विषय:- वन मंडल अनूपपुर के परिक्षेत्र कोतमा के विभिन्न वनकक्षों के रकबा 314.743 हे. वनभूमि एवं ग्राम फुलकोना, डुमरकछार तथा भलगुडी के विभिन्न खसरो के रकबा 39.515 हे. राजस्व वनभूमि कुल 354.258 हे. वनभूमि में झिरिया वेस्ट ओपन कास्ट पद्धति से कोयला उत्खनन व्यपवर्तन का -वेस्टर्न कोलफील्ड्स लि. का ऑनलाईन प्रस्ताव क्र. **FP/MP/MIN/39881/2019**

**Subject:** Proposal for diversion of 354.258 Ha of forest land/ revenue forest land (314.743 ha of forest land + 39.515 ha of revenue forest land = 354.258 ha forest land) for Jhiria West Opencast coal mining in favour of M/s South Eastern Coalfields Limited, Anuppur district, State of Madhya Pradesh (Online proposal no. FP/MP/MIN/39881/2019)- Reg.

Subject: Proposal for diversion of 354.258 ha of forest land/revenue forest land (314.743 ha of forest land + 39.515 ha of revenue forest land = 354.258 ha forest land) for Jhiria West Opencast Coal Mining in favour of M/s. South Eastern Coal Fields Limited, Anuppur District State of Madhya Pradesh (Online No. FP/MP/MIN/39881/2019) - regarding.

**STAGE PLANS:**

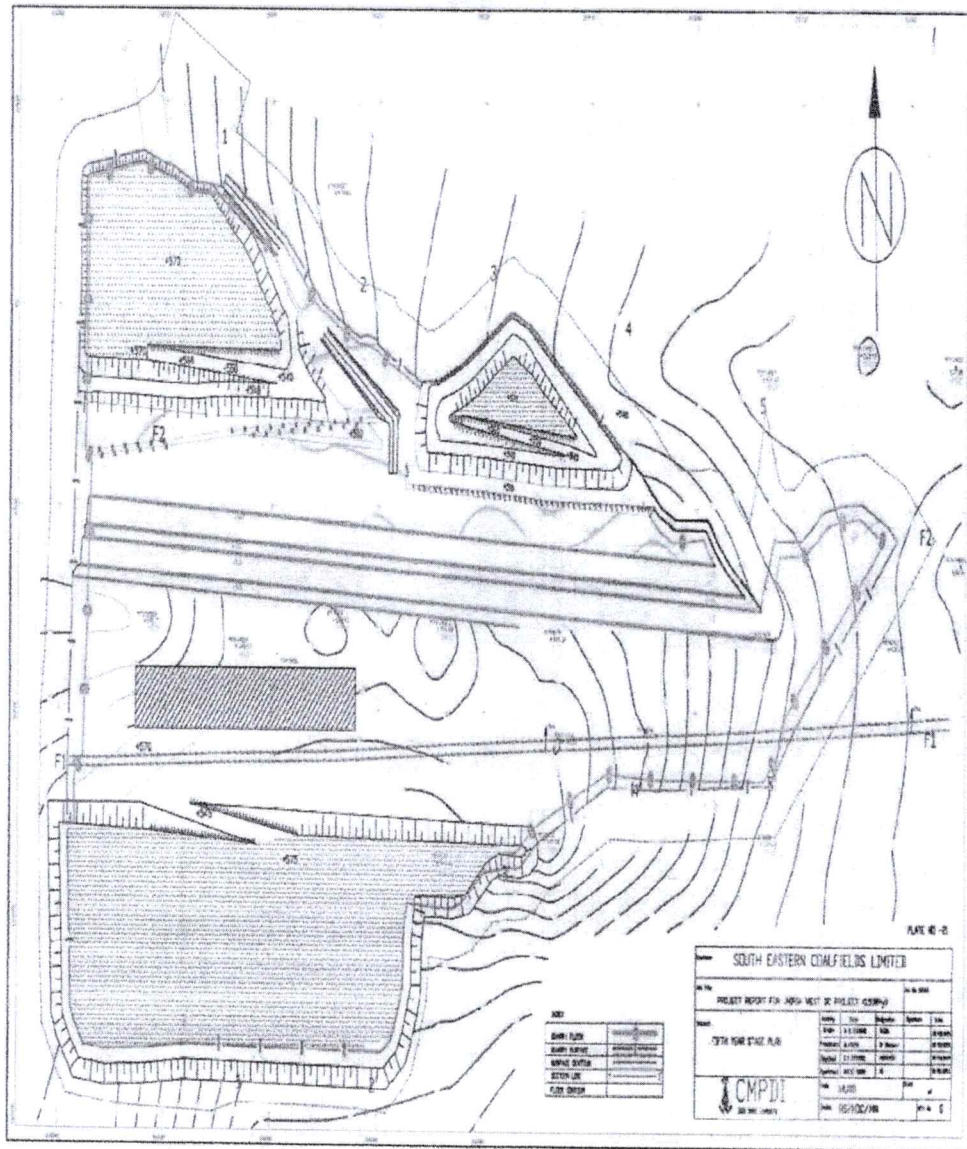
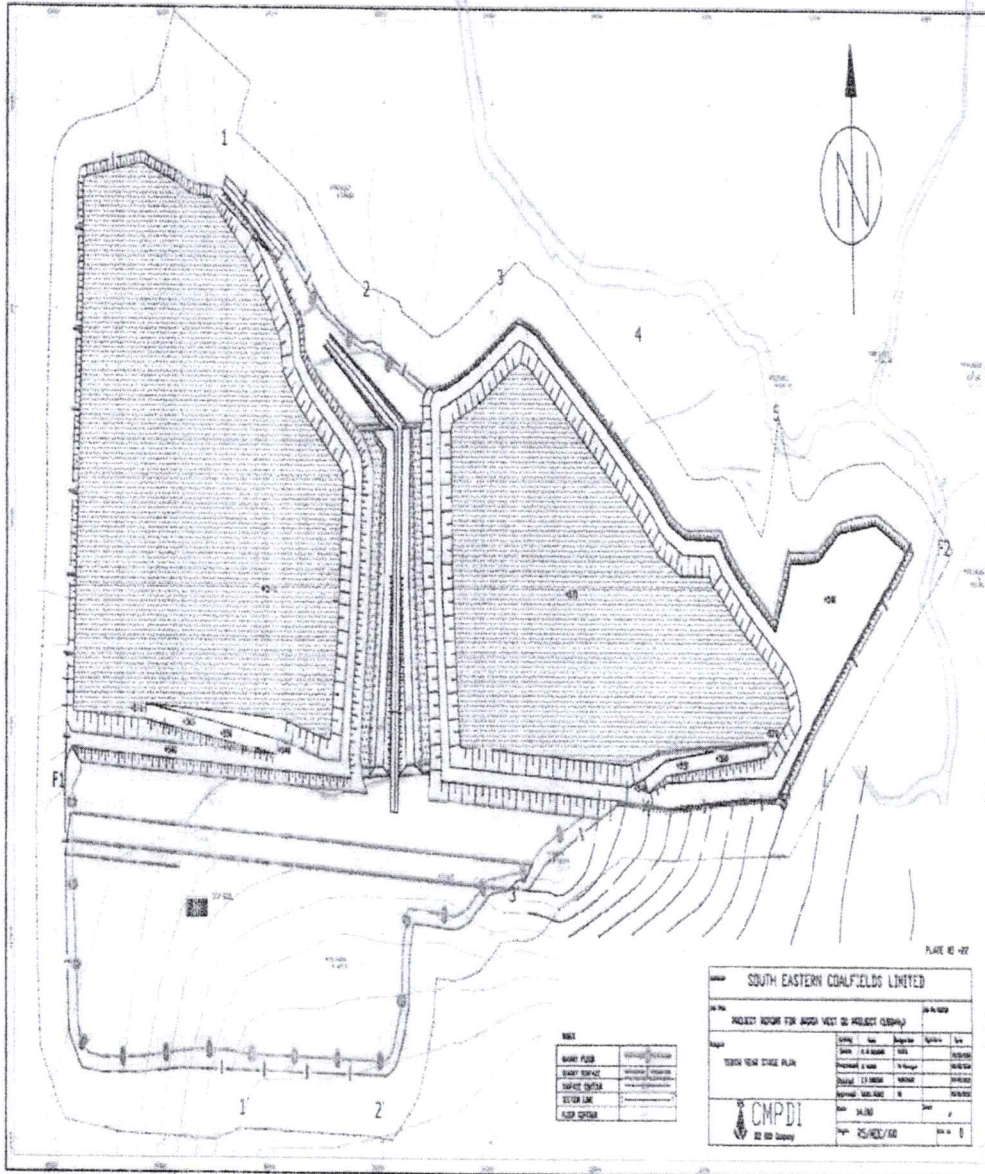
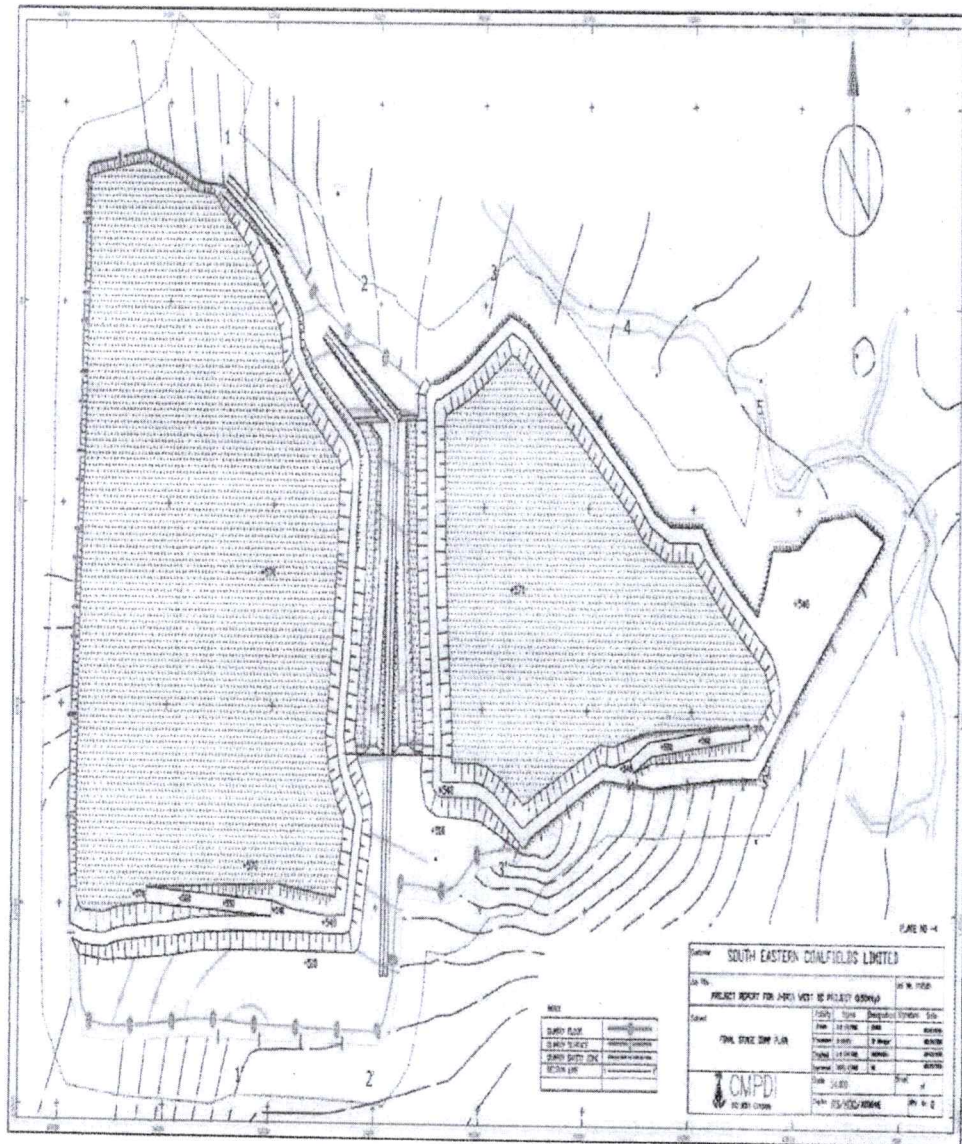
- i. The state shall provide the details of other projects of the user agency which are proposed to be used for over burden dumps, Belt, CHP & Siding etc. The details of forest land diversion in these projects along with status of compliance of the stipulate conditions under FCA shall also be provided.

**Reply- No overburden will be dumped in any other project.** As indicated in Project Report, overburden quantities will be dumped within quarry area of instant project. (Copy of Mining plan showing Stage Plan enclosed ).
